Save Del Cerro

All Peoples Church
Project No: 636444

Main Discussion Points

Table 5.1-2
NAVAJO COMMUNITY PLAN GOALS AND RECOMMENDATIONS CONSISTENCY EVALUATION

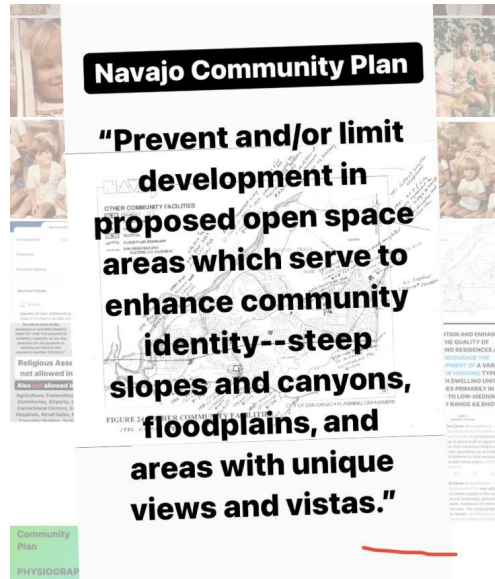
Why are these important principal objectives of the Navajo Community Plan simply stricken from the Final EIR?

Multipurpose Room

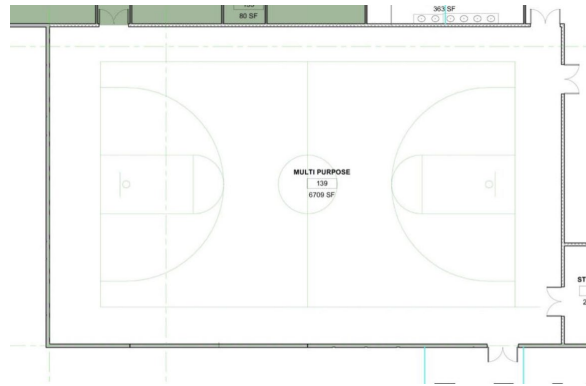
Previously discussed low basketball gym ADT

7,000 sf multi-purpose gym with expected 0-10 ADT?

This low ADT estimate allows the project to come in <300 ADT and qualify as a **“Small Project”**
